TRINITY METROSM

IFB-23-T026

ADDENDUM #3

THIS ADDENDUM IS ISSUED TO: Revised Plans based on Questions Received

SHEET
 C6.1

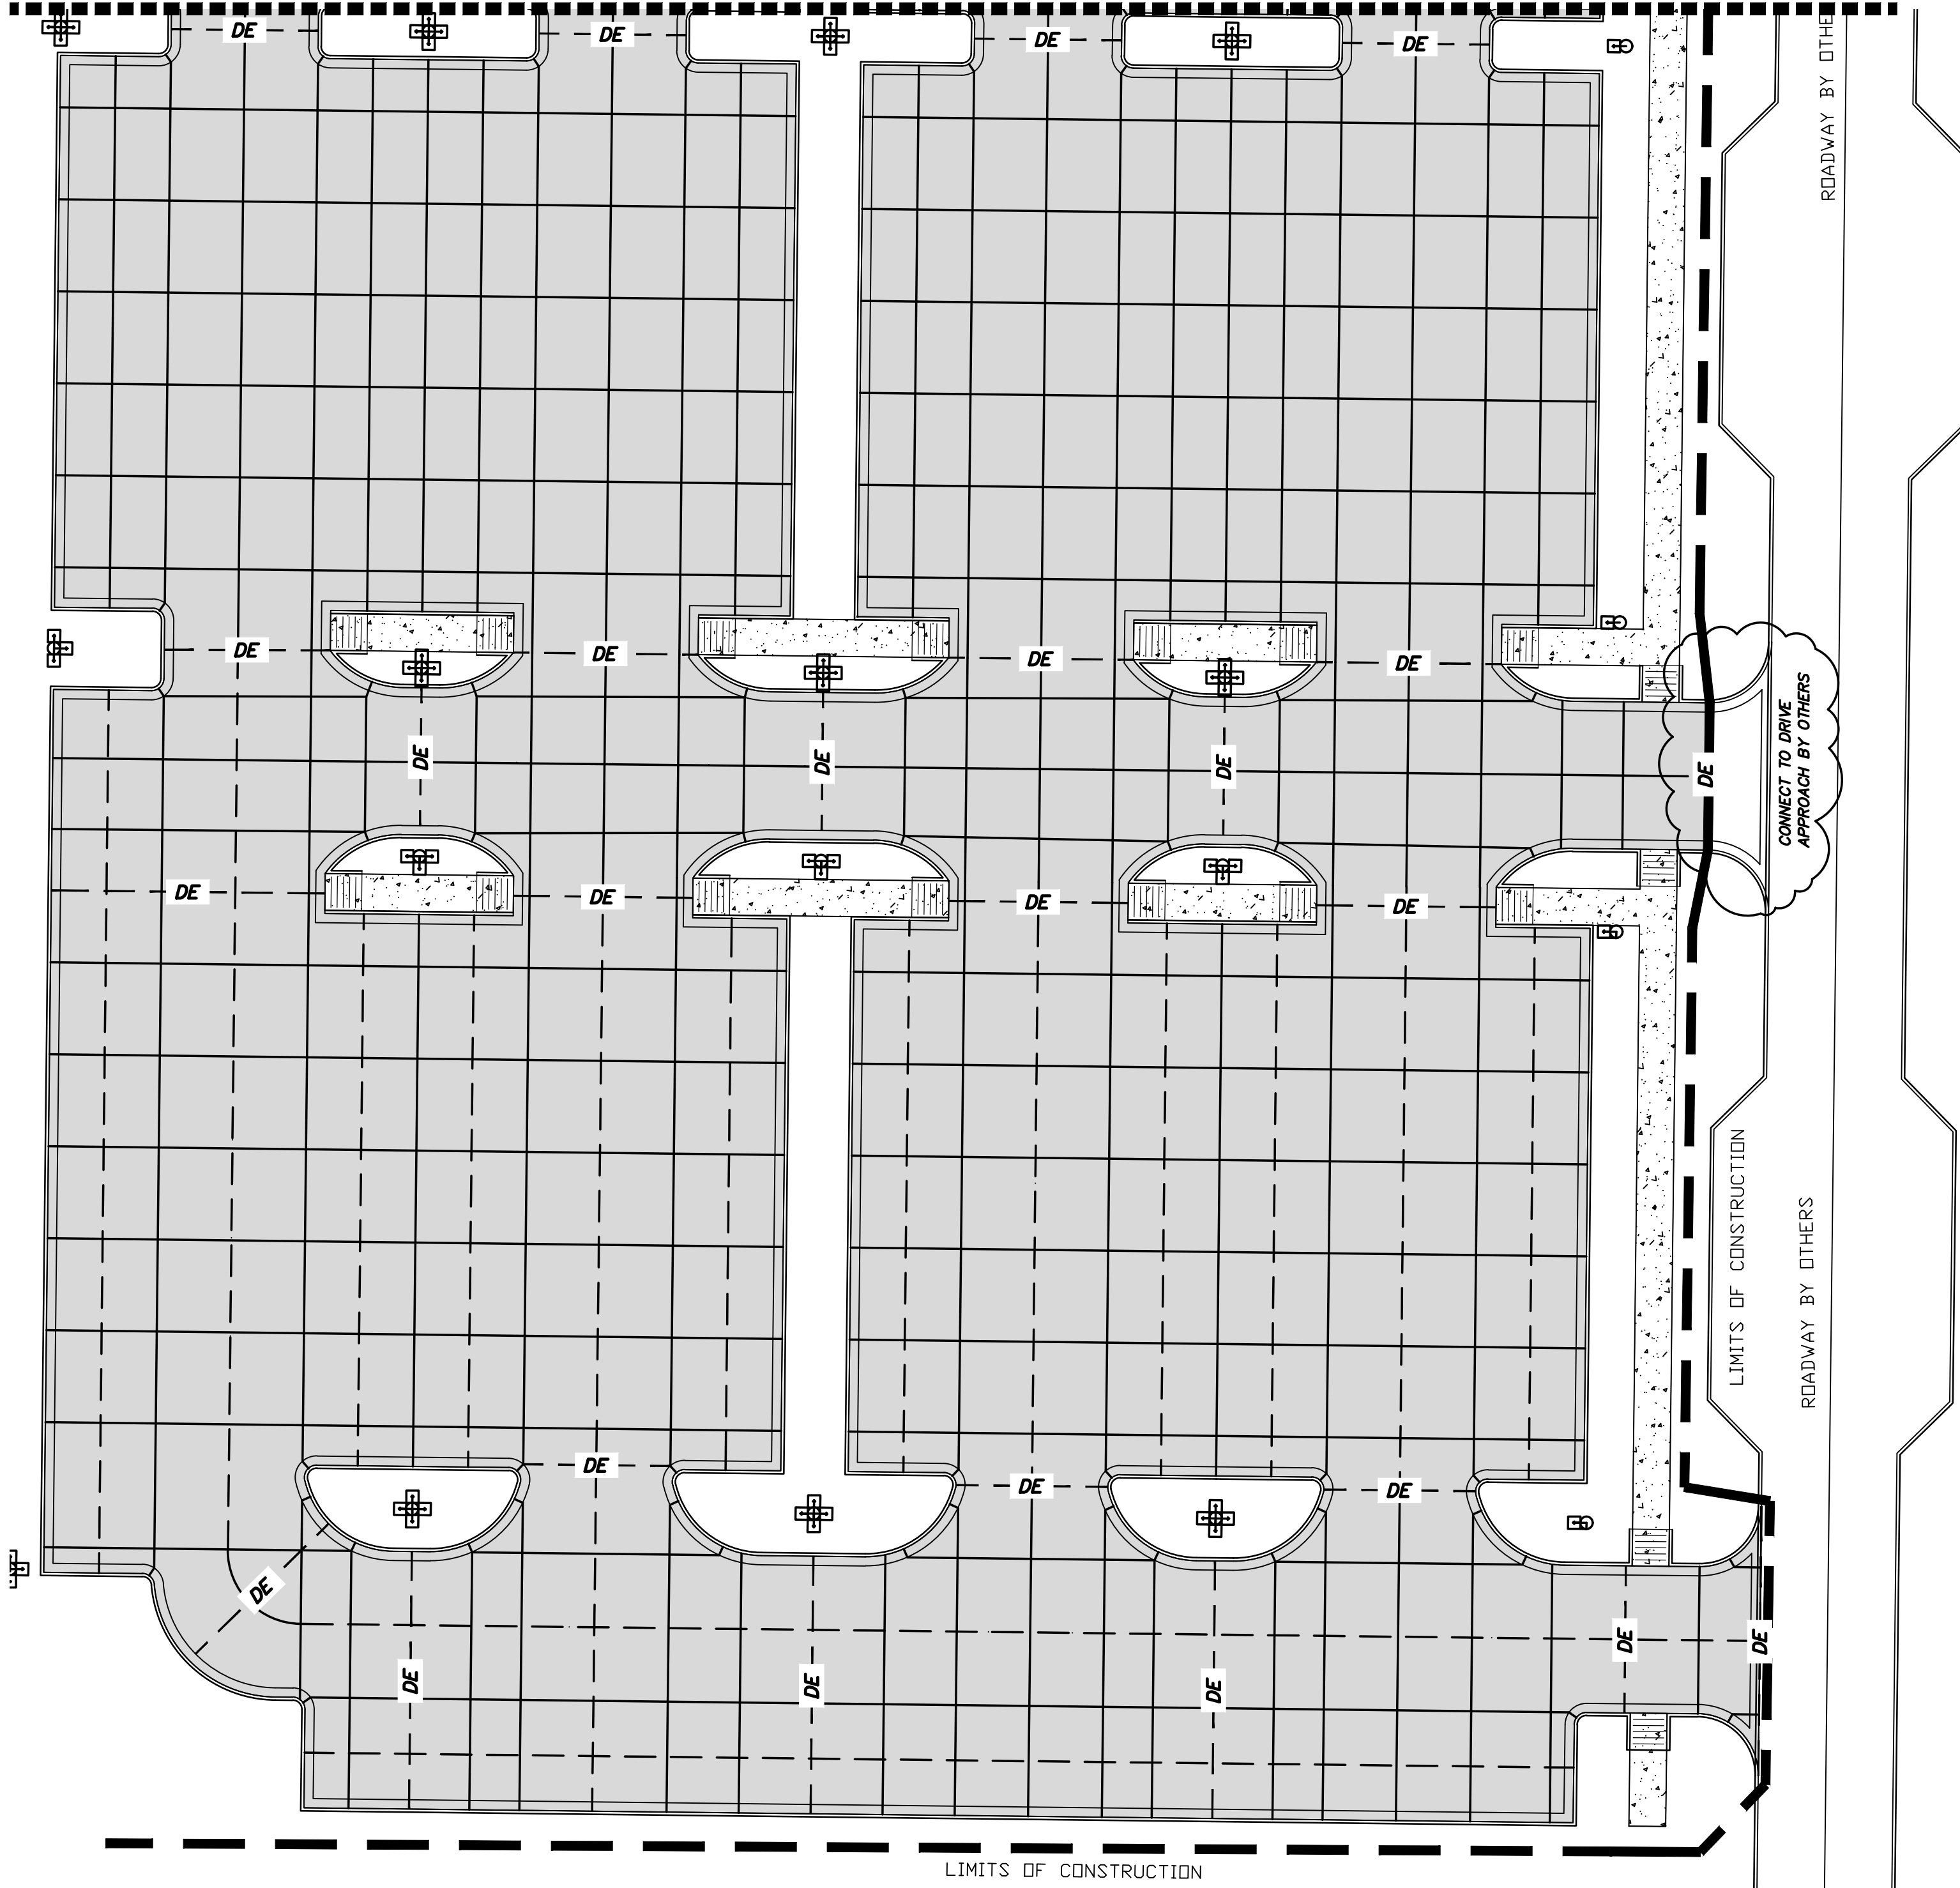
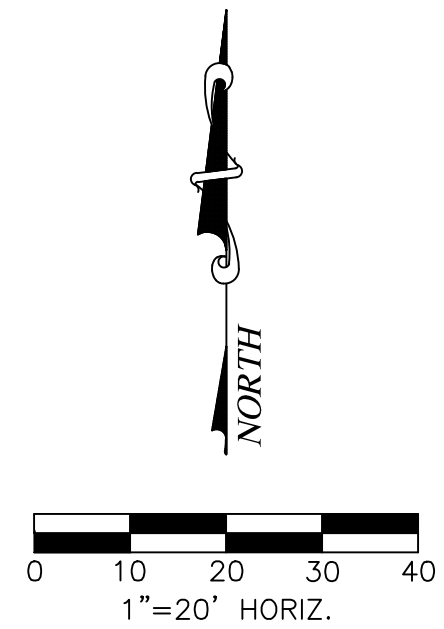
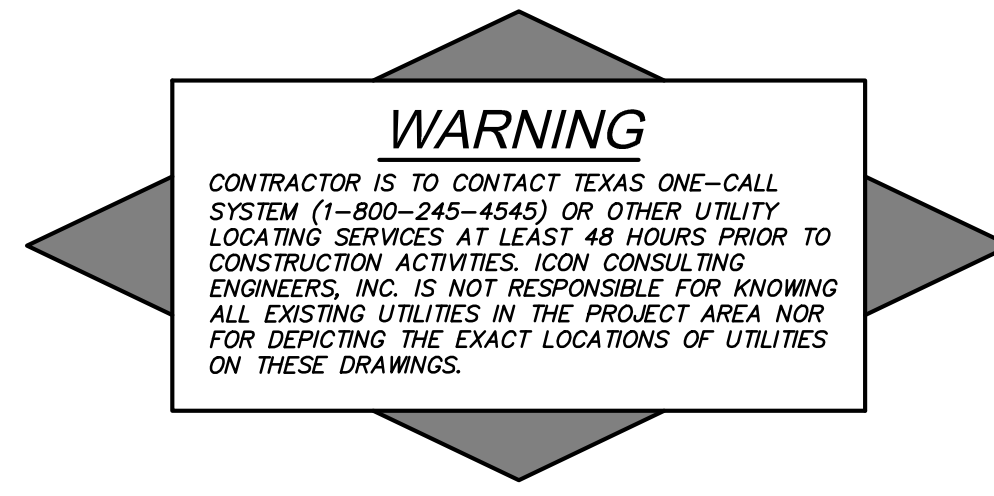
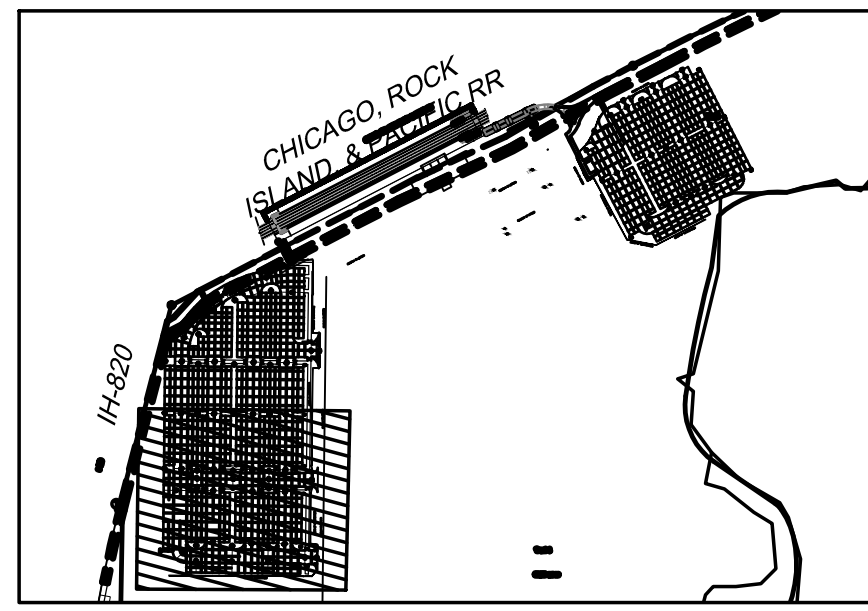
The legend on the C6.1 indicates 6" concrete paving on top of 8" compacted subgrade. Paving notes #5 on this same sheet states that hydrated lime (IF REQUIRED) shall be 6% at 6" thick. Section C.1.c of Geotechnical Report indicates 5" concrete paving on top of 6" lime-treated and cement-treated base. Please clarify the thickness of the concrete paving and the make-up of the paving sub-base (compacted grade, lime, and/or cement).

Sheet C3.1 appears to show the 30" HDPE storm line ending at a headwall with riprap right in the middle of a proposed drive approach. Please clarify the placement of this headwall and riprap.

Revised Drawings C6.1, C6.2 and C6.3 are attached.

Revised Drawing C6.1 is attached.

SHEET
C3.2

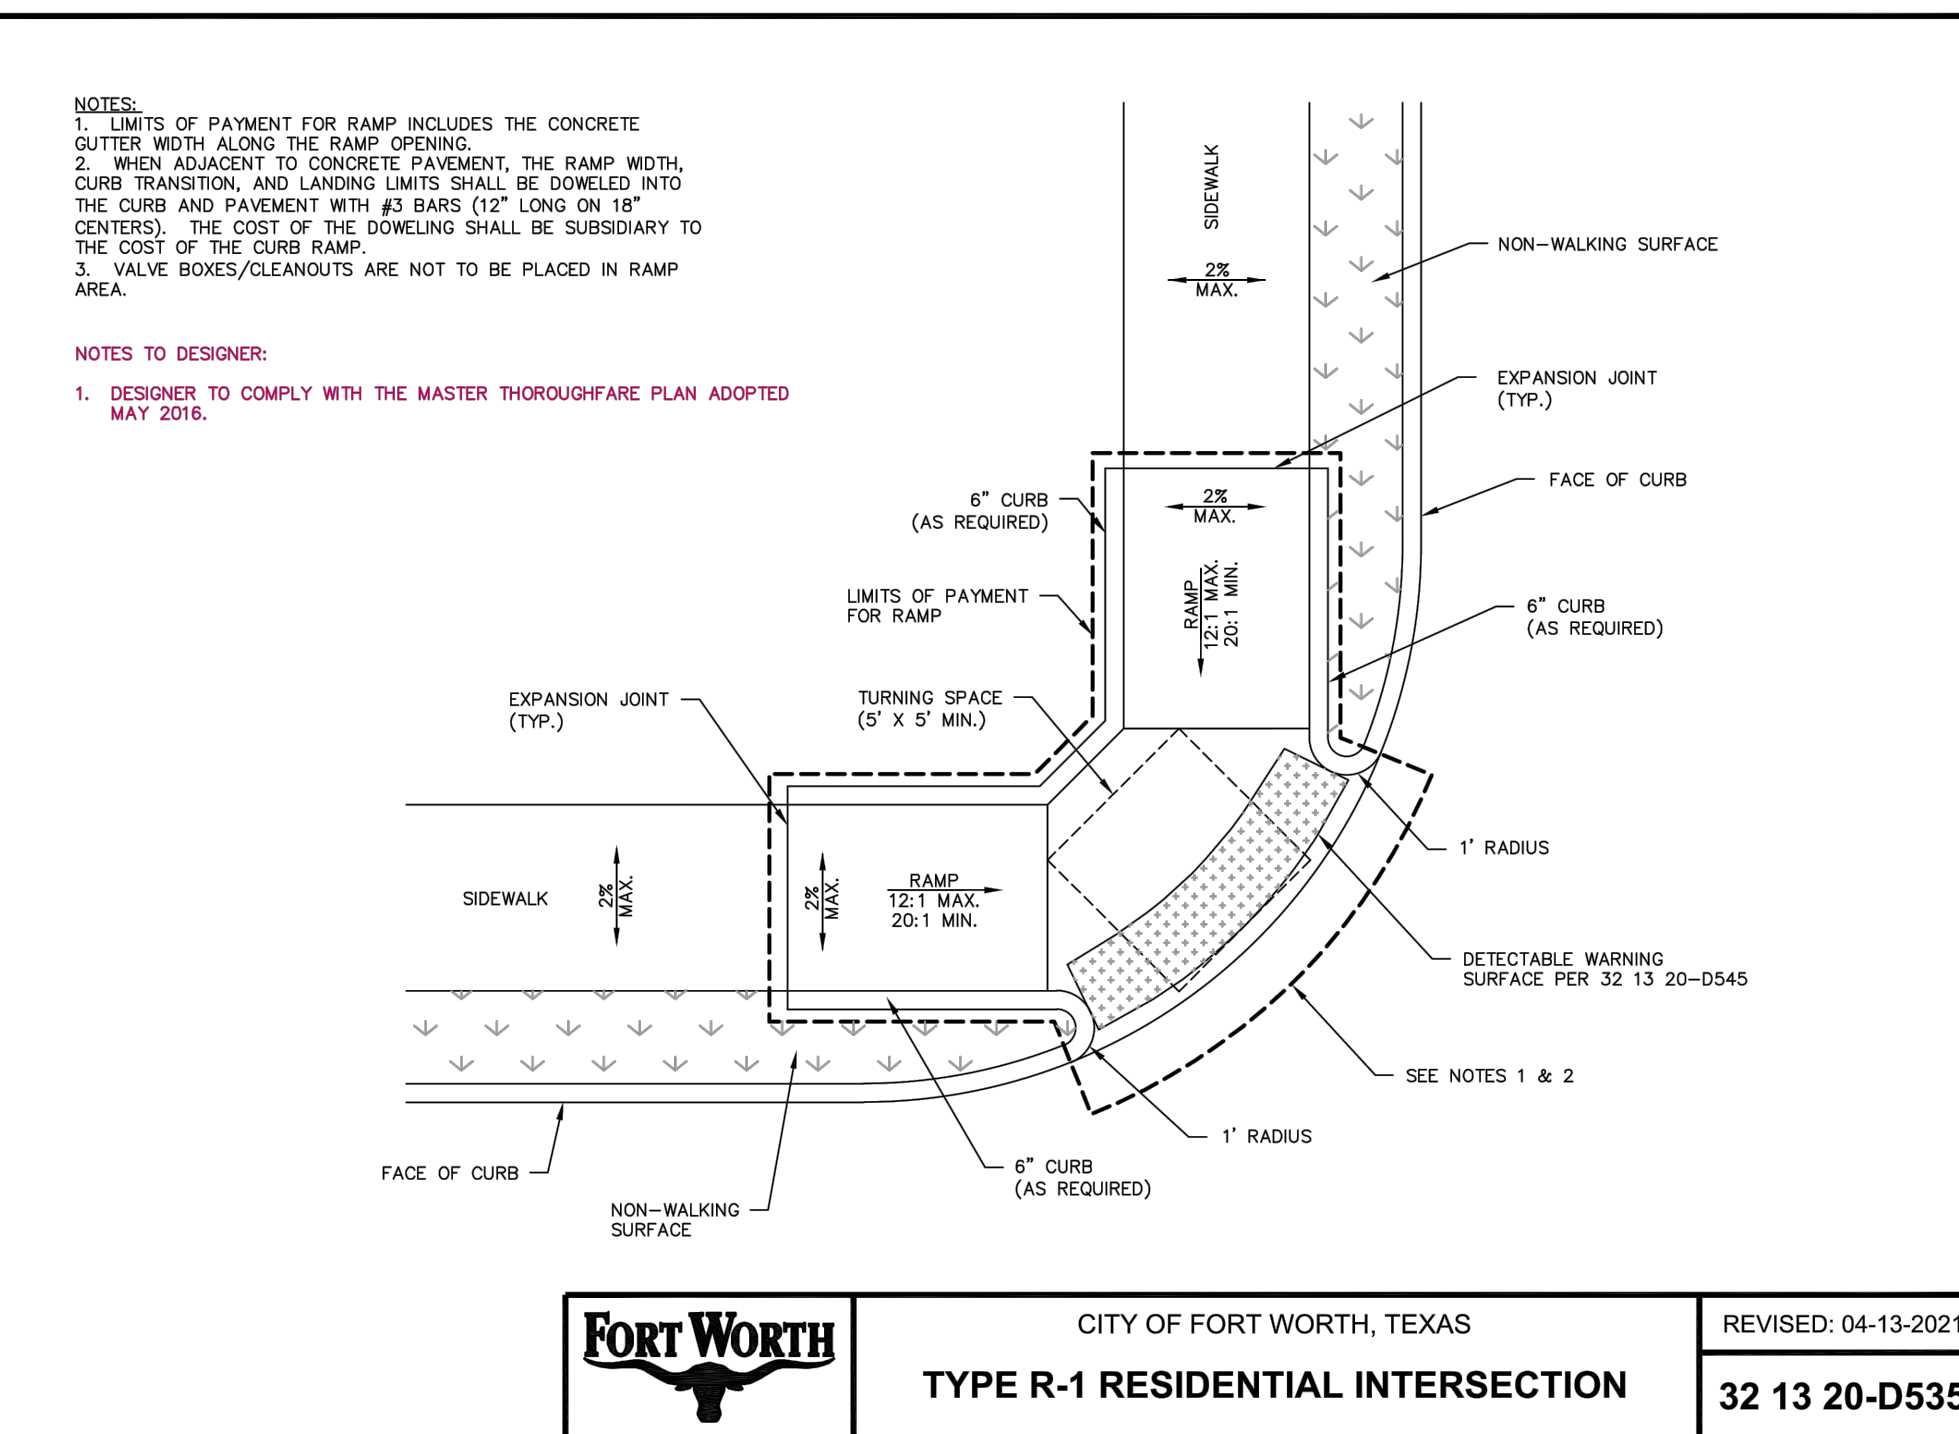
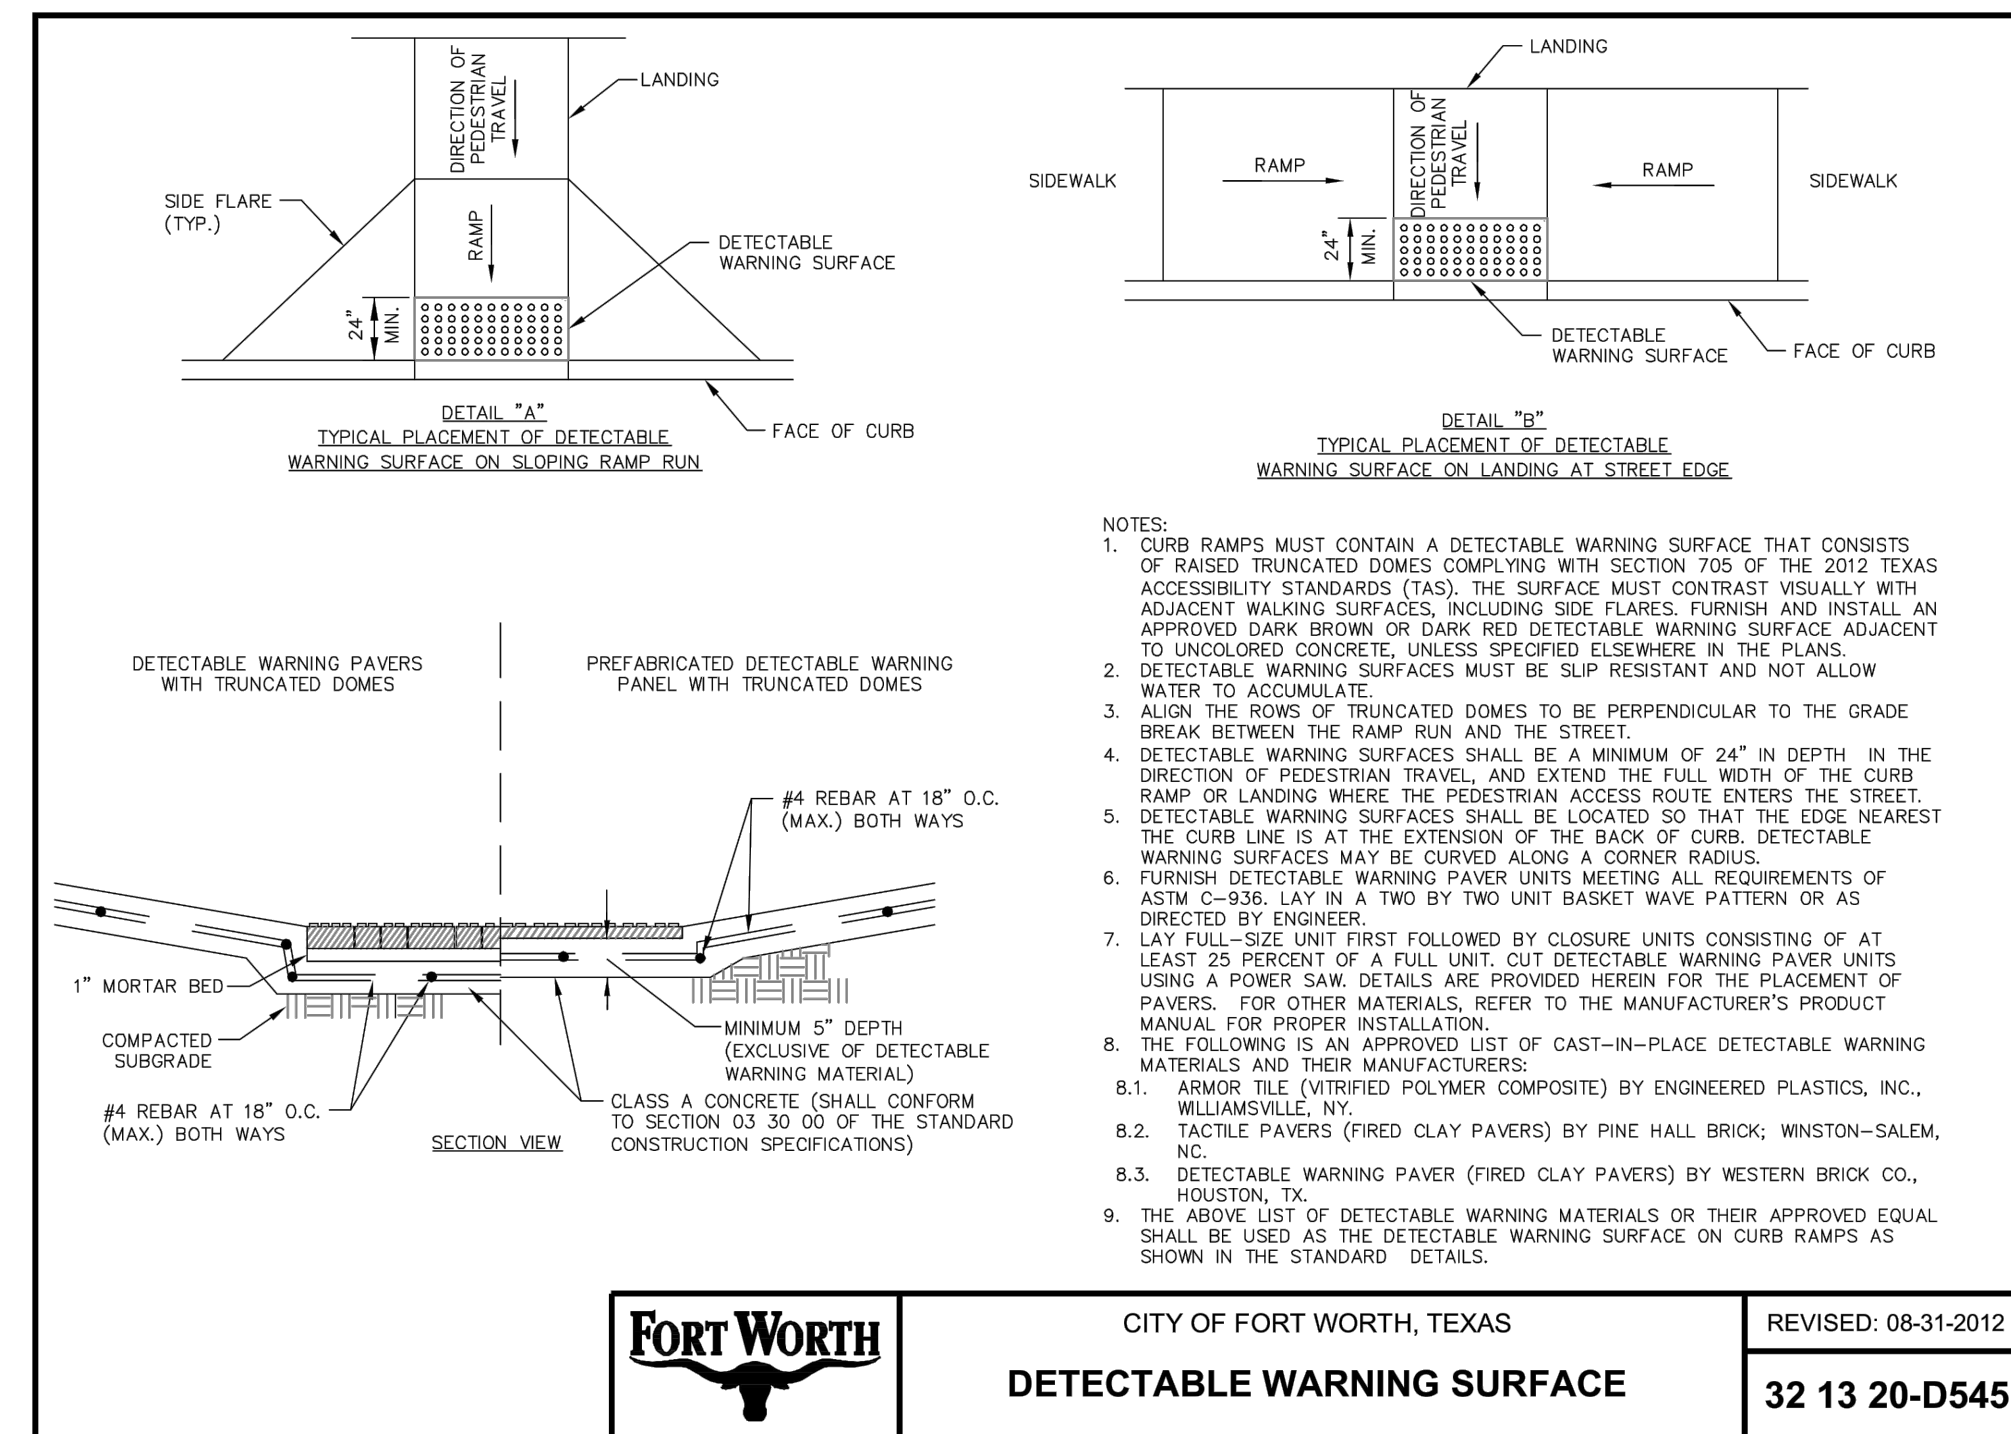
Sheet C3.3: None of the contour lines for existing grades are labeled. Please provide the elevations for the existing contours.

Revised Drawing C3.2 is attached showing the existing contour elevations.
